**BOULDER COUNTY PLANNING COMMISSION
PUBLIC HEARING**

STAFF RECOMMENDATION

Docket SU-24-0002: Pivot Solar Energy Facility

Request: Special Use Review for an approximately 4-acre solar energy facility on a 13-acre parcel at 9215 Arapahoe Road.

Figure 6: Proposed vegetative screening (note: north is to the right in map); sample images of Smith Buckthorn (lefthand image) and Red Osier Dogwood in the summer (center image) and winter (righthand image).

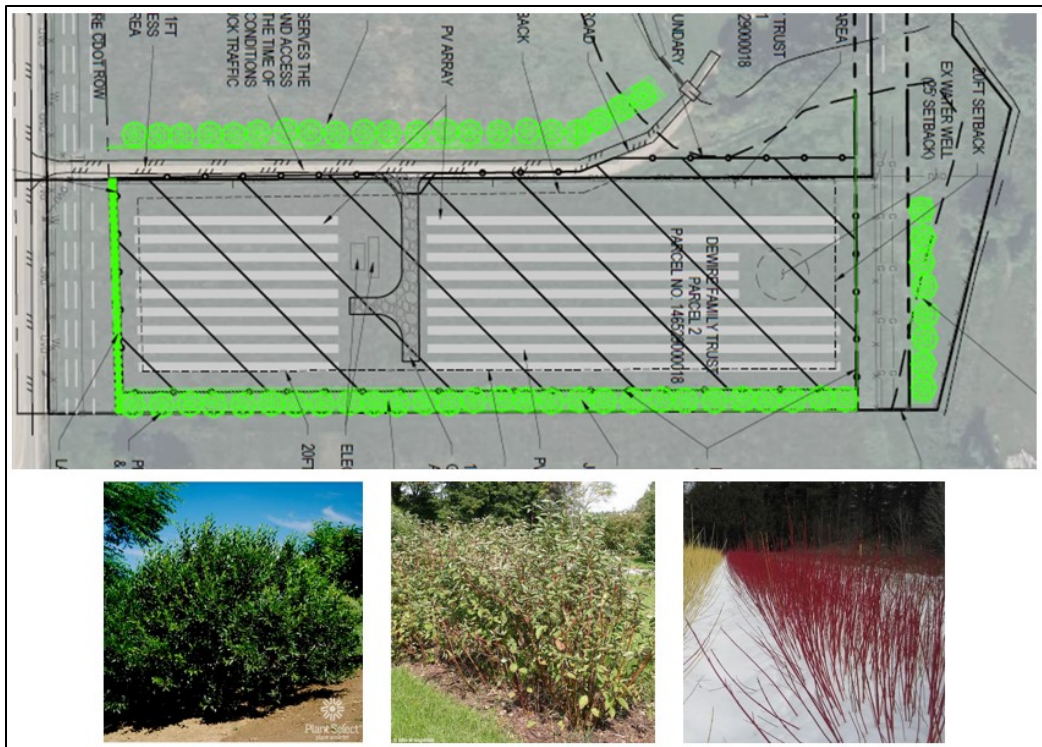
Staff find that the proposed vegetative screening will help to reduce and mitigate the visual impacts of the proposed project. However, given that the proposed plantings are between five and eight feet tall at the lower end of their typical growth, staff finds there is still the potential for significant visual impacts from panels at a height of 12 feet above existing grade. At 12 feet above existing grade, potentially as much as seven feet of the panels would be visible above the vegetation. To further mitigate the visual impacts of the proposed panels, staff recommend as a condition of approval that the maximum height of the panels be limited to no more than 10 feet above existing grade. This will help to ensure that at least half of the panels' height is screen by the vegetative plantings. Staff find that 10 feet above grade is an appropriate height limit as that is the height which the county has determined to have minimal visual impacts from solar arrays. This determination was reflected in the Land Use Code amendments related to Accessory Solar Energy Systems adopted by the Board of County Commissioners in January 2023 (docket DC-22-0002).

16. The applicants must remove and replace any of the vegetative screening that dies or fails throughout the life span of the facility.
17. The maximum height of the panels shall be limited to no more than 10 feet above existing grade.

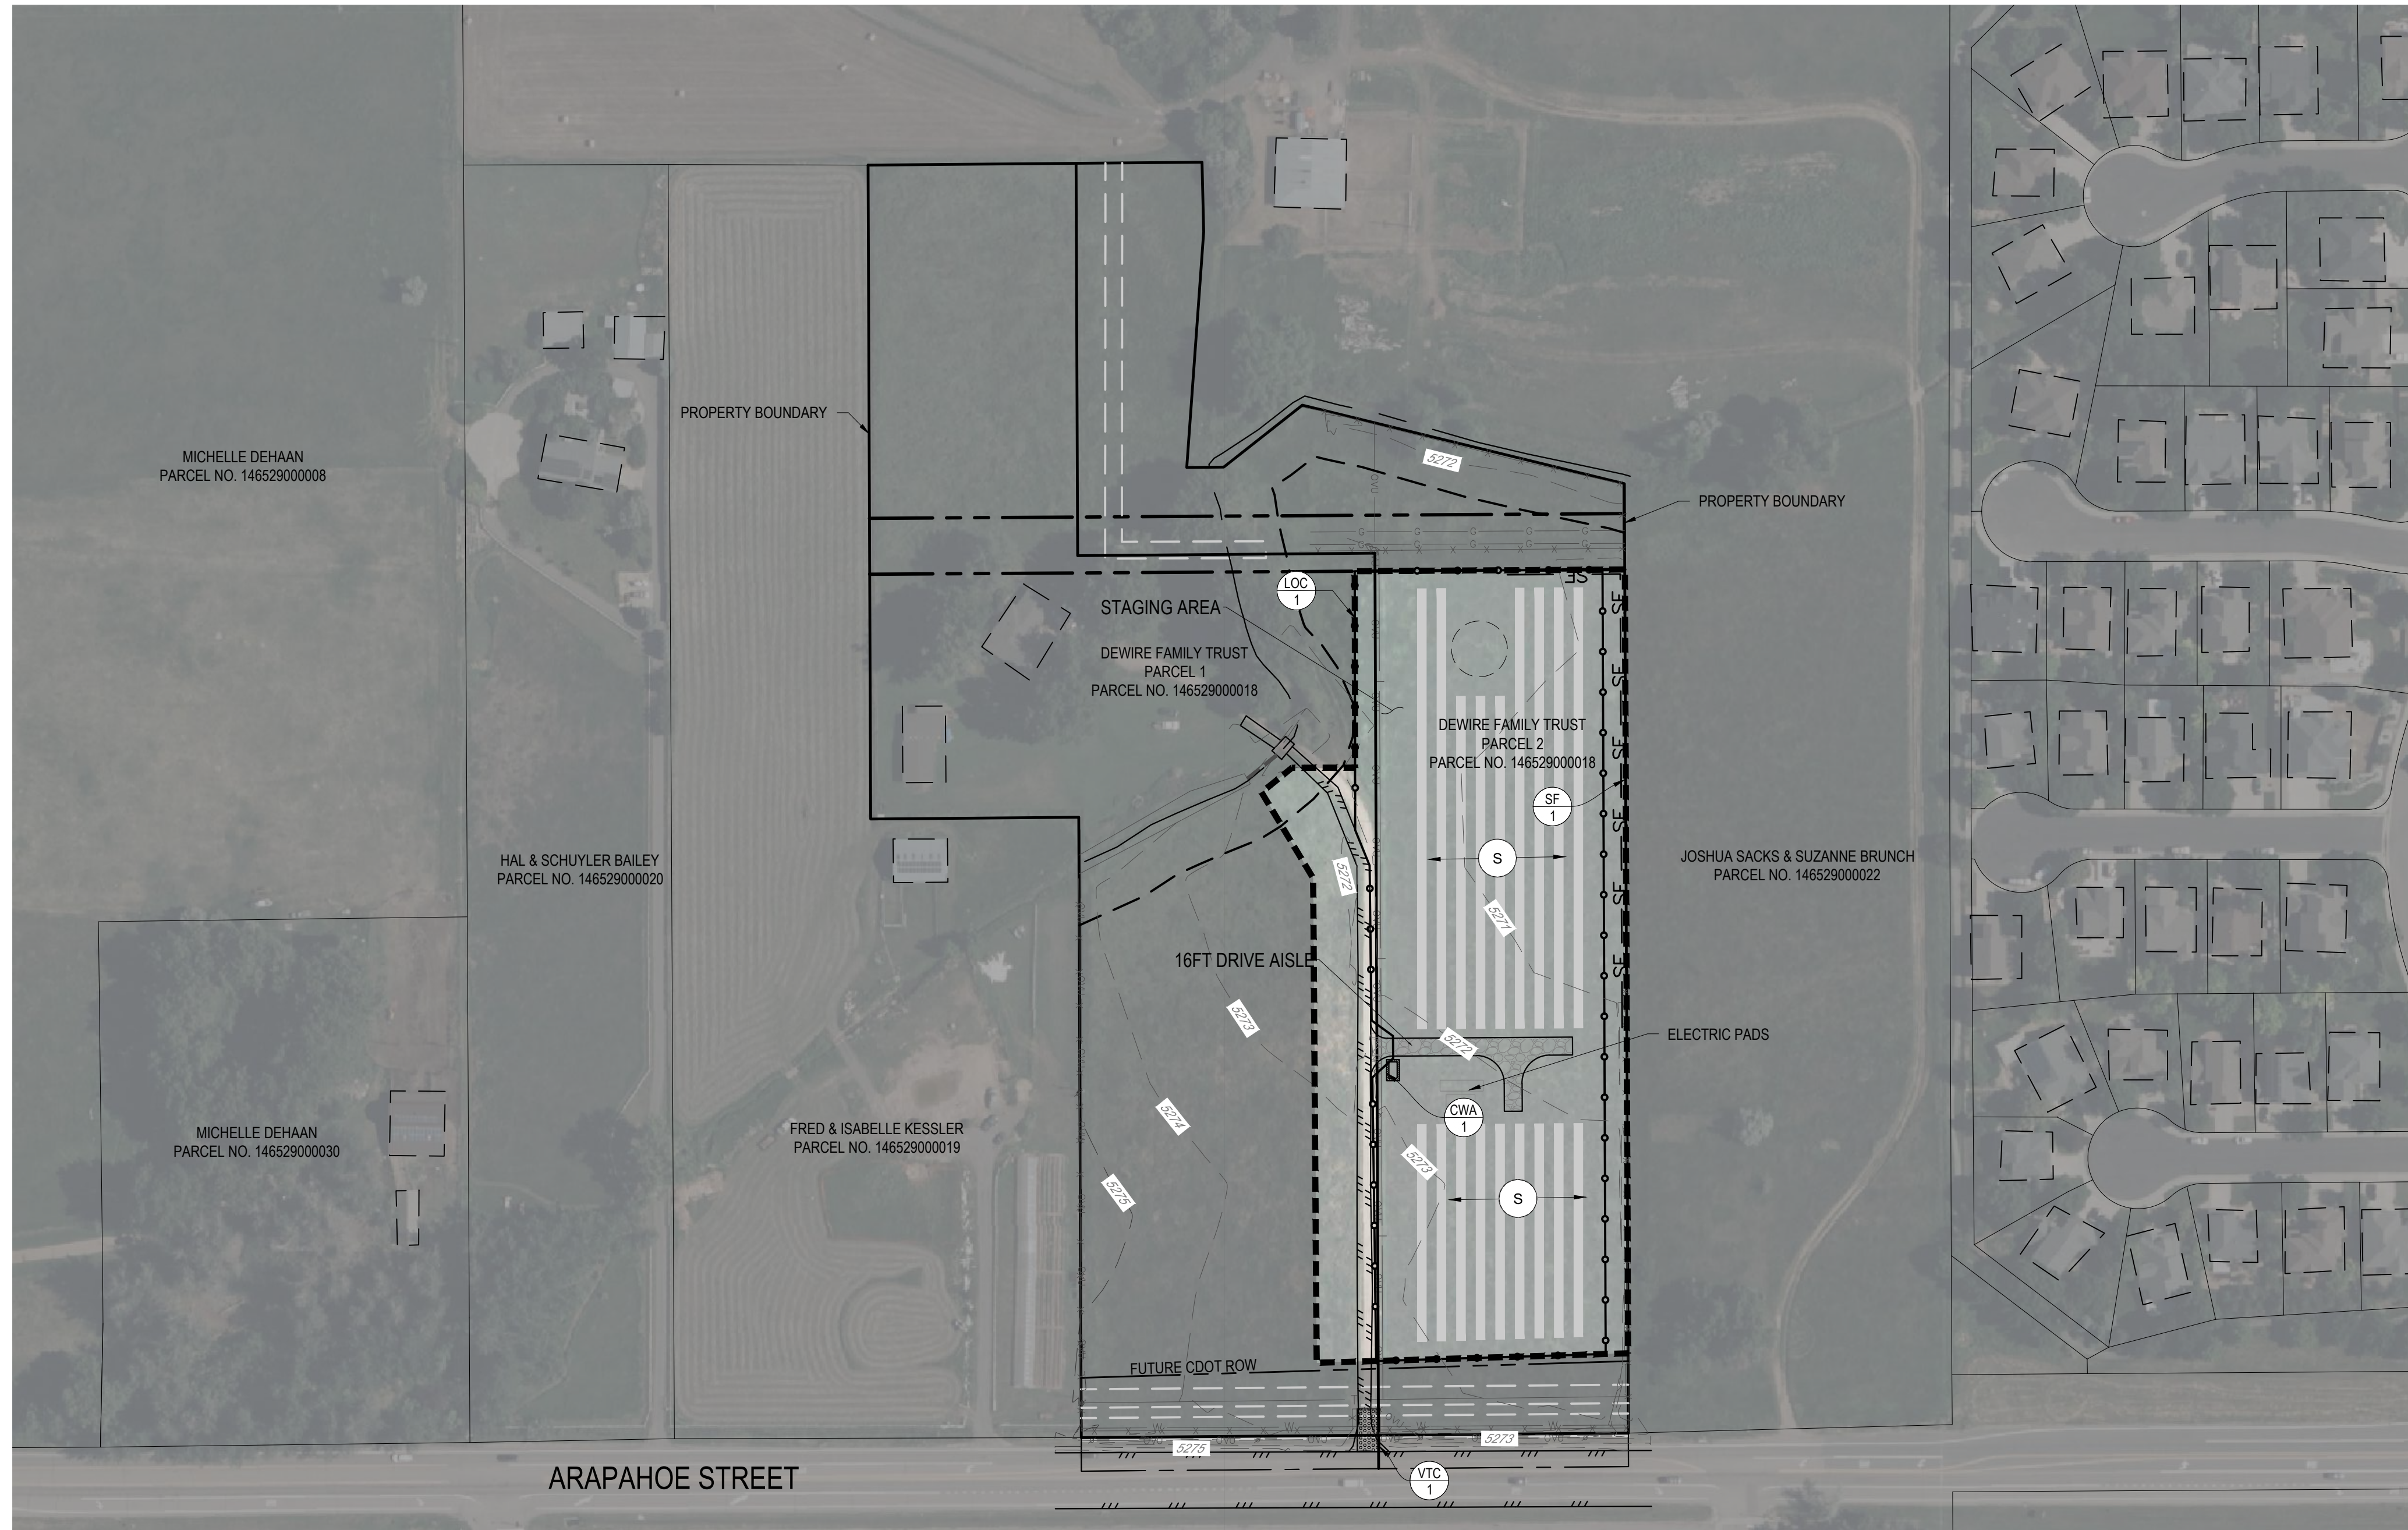
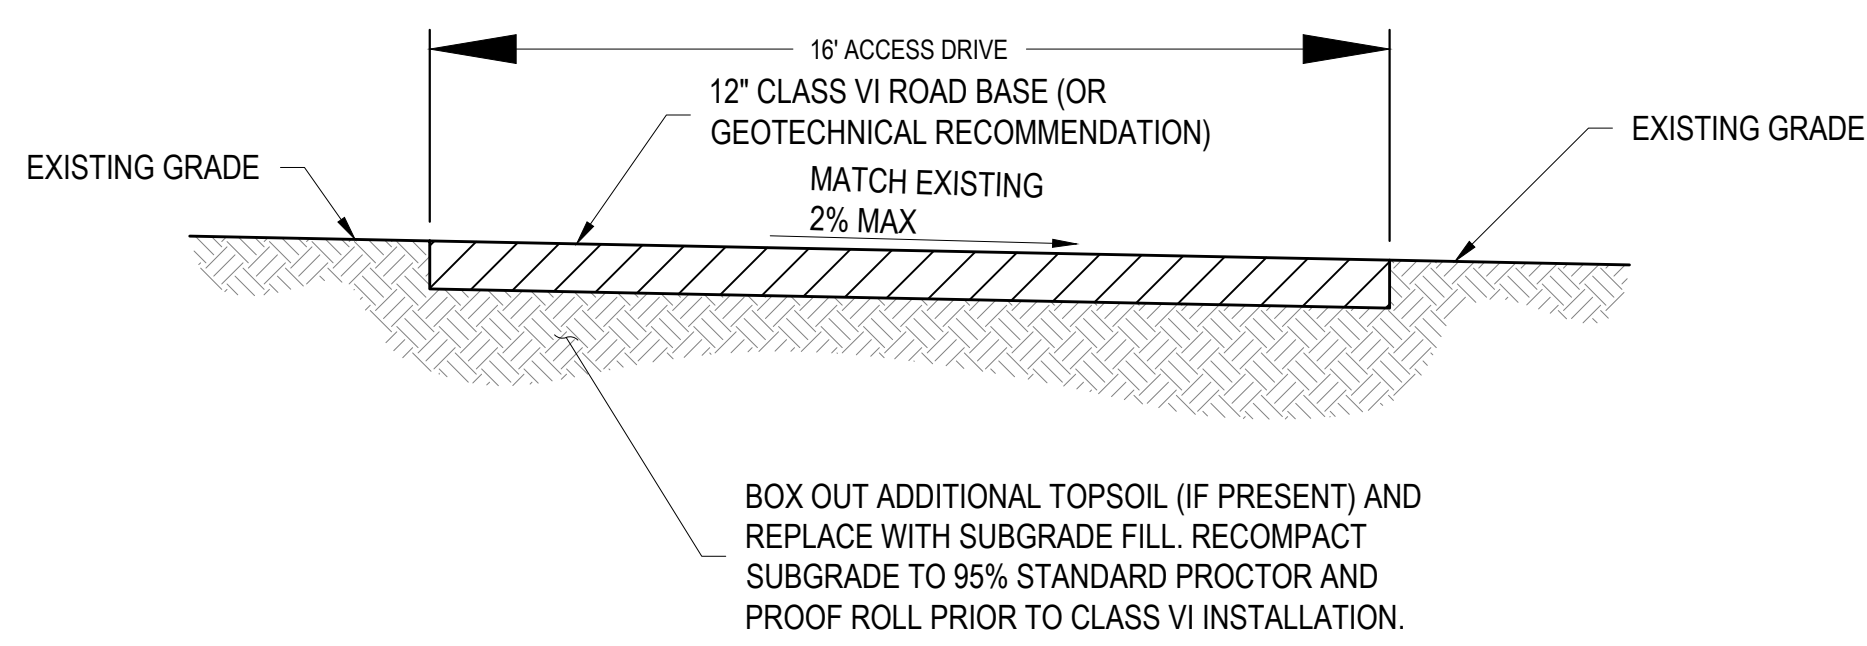
The landscaping berms on Sheet 1 of the Landscaping Plan should not be approved. They "elevate" the root area of plantings, subjecting them to winter freezes, as well as increased evaporation in summer. Since there are no excavations proposed, would the berms be "mounded" from existing nearby topsoils, and thus remove topsoils from rather large areas? Or, would material for the berms be imported, and if so what kind of material, from what source, and how would the importation of weed seeds be prevented?

FIGURE 1 - VICINITY MAP
PIVOT ENERGY SOLAR FARM ON DEWIRE PARCEL
BOULDER COUNTY, COLORADO

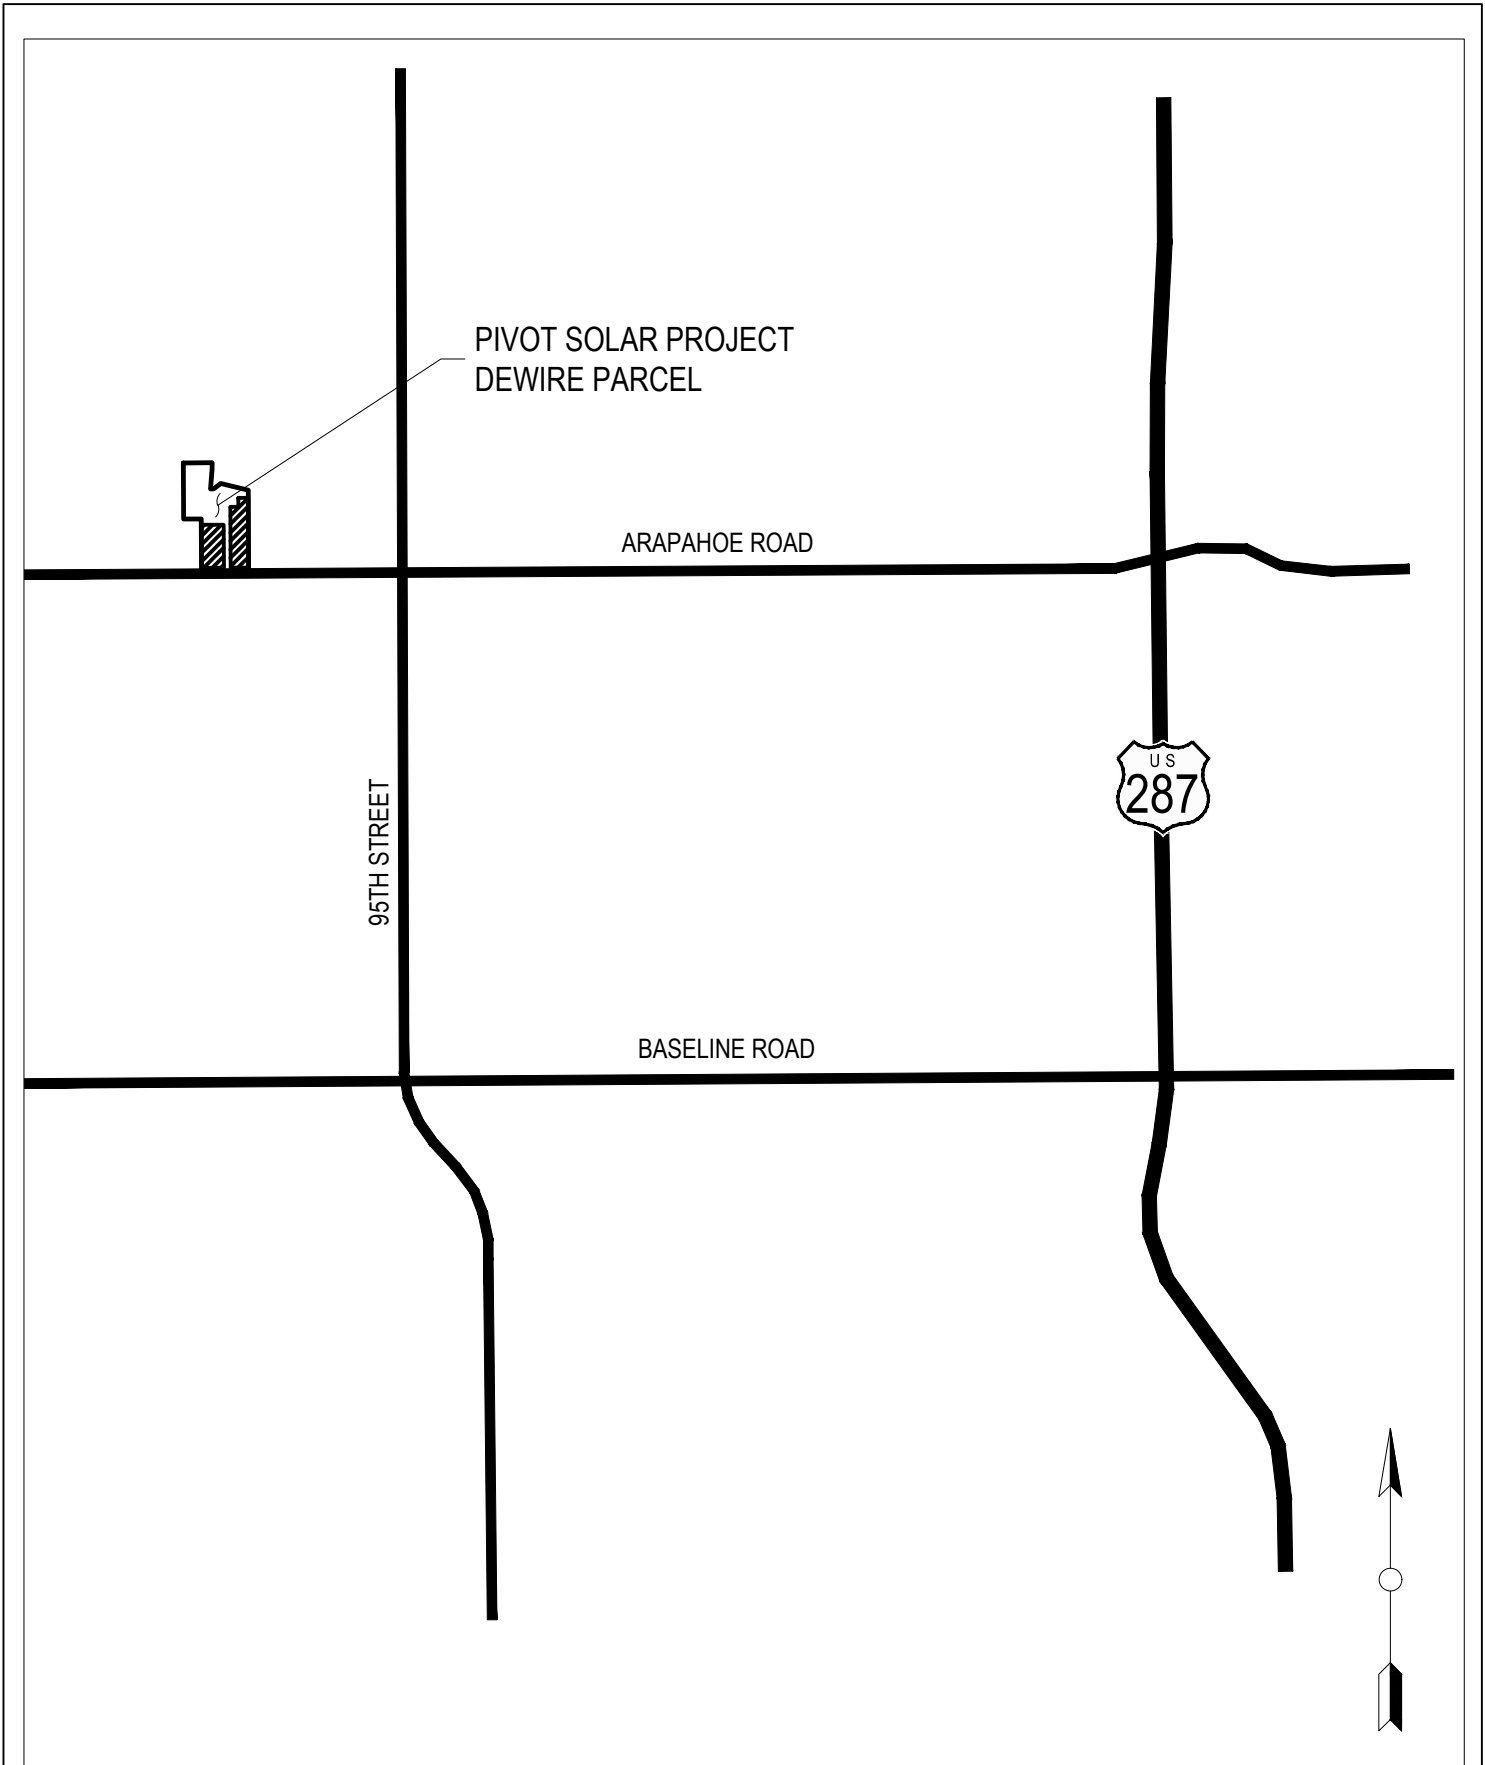
Did not review. Will review on next round of review once imperviousness values are corrected.
